**Comments of LS Power Grid New York, LLC on
Updated Straw Proposal to Address Upgrades
in the Public Policy Transmission Planning Process**
September 5, 2019

LS Power Grid New York, LLC (“LS Power”) offers the following comments in response to the Updated Straw Proposal to Address Upgrades in the Public Policy Transmission Planning Process (“Straw Proposal”) as discussed at the August 20, 2019 joint meeting of the Transmission Planning Advisory Subcommittee (“TPAS”) and Electric System Planning Working Group (“ESPWG”).

Example 1: Increase the rating of a 345 kV line by replacing an existing wavetrap

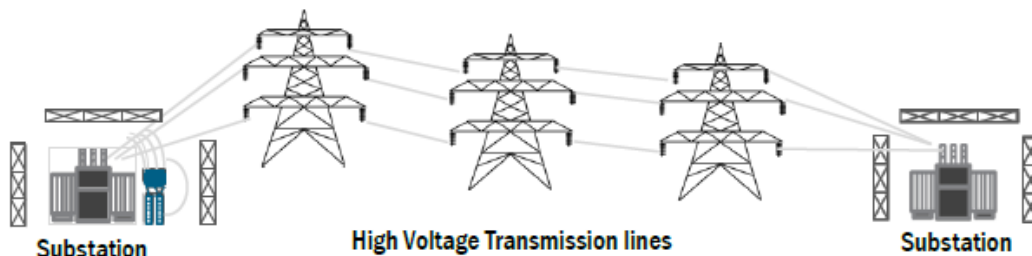
This example would be an upgrade under Section 31.6.4 as it represents an improvement to an existing transmission and does not add a new electrical pathway or functionality, or function electrically independent.

Example 2: Reconductor an existing 230 kV transmission line with a 345 kV conductor on the existing structures with same substations

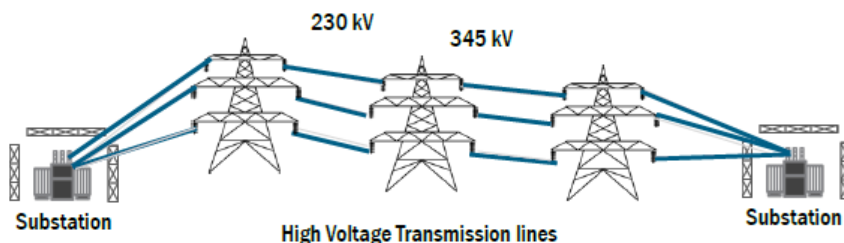
This example requires some additional information in order to reach a conclusion. The description in the upper text implies only a change in conductor, while the lower text describes a change in voltage. For the purposes of the discussion, we assume the example intends only a reconductor to a 345 kV capable conductor, without a change in voltage.

A scenario where an existing 230 kV transmission line is reconducted on the existing structures would be an upgrade under Section 31.6.4. This would represent an improvement to an existing transmission and does not add a new electrical pathway or functionality, or function electrically independent.

Example 3: Replace an existing 115kV transmission line with a 230 kV transmission line by removing the existing 115 kV line and rebuilding a 230 kV line on new structures, new insulators, etc. in the same right-of-way with same substations

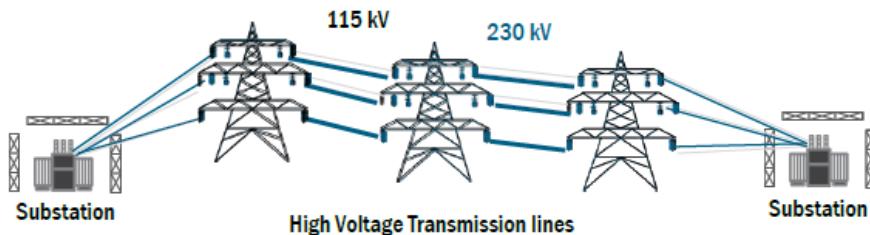
This example is electrically impossible, since a 230 kV transmission line cannot connect to the same 115 kV substations. It is possible that the 115 kV substations also have facilities at 230 kV, but the 230 kV bus would be considered to be a different terminal from a transmission planning perspective, with a different bus number. A line between the 230 kV busses would represent a new electrical pathway. More likely this scenario would require one or more new 230/115 kV transformers in order to be implemented, which would also represent a new electrical pathway, and function electrically independent.

In either case, with or without new 230/115 kV transformers, this example would not be an “upgrade”. The new 230 kV transmission line is an “entirely new facility” and therefore not an upgrade under FERC Order No. 1000-A or Section 31.6.4. Furthermore, the new 230 kV transmission line would add a new electrical pathway that did not exist prior to the expansion. The system topology would be significantly different with a higher voltage transmission line. If new 230/115 kV transformers were added, they would function independently from existing transmission facilities. Each of these facts would not be an upgrade under the guidance on Slide 14. The conclusion in the presentation that Example 3 would represent an upgrade under Section 31.6.4 is not consistent with the plain language of Section 31.6.4 or with the interpretation of Slide 14.

Example 5: Build a new 115 kV transmission line and new structures in an existing ROW

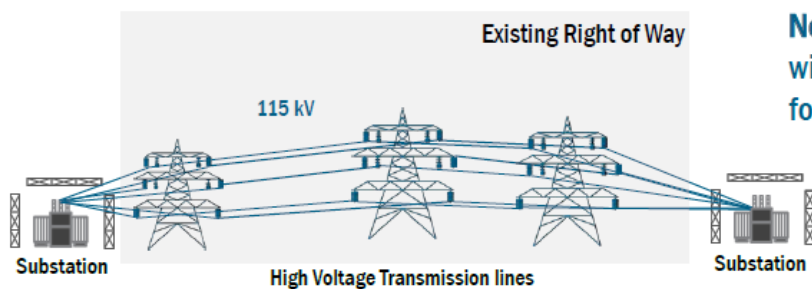
This scenario does not represent an upgrade under Section 31.6.4. It represents both an “entirely new facility” under FERC Order No. 1000-A and Section 31.6.4 and adds a new electrical pathway under the guidance on Slide 14, in each case not qualifying as an upgrade.

Example 7: Relocate an existing substation to accommodate a proposed project by building a new 345 kV substation near the existing substation and routing all transmission circuits from the existing substation into the replacement substation and removing the existing substation

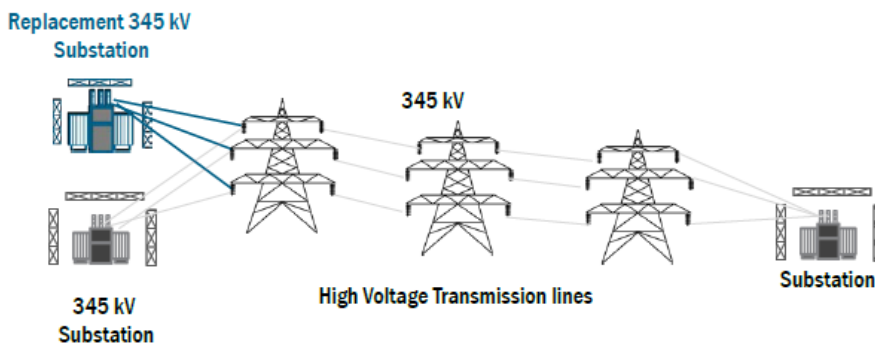
As discussed above, a relocation of an entire substation would represent an entirely new facility, and would not be considered an upgrade under FERC Order No. 1000-A or Section 31.6.4.
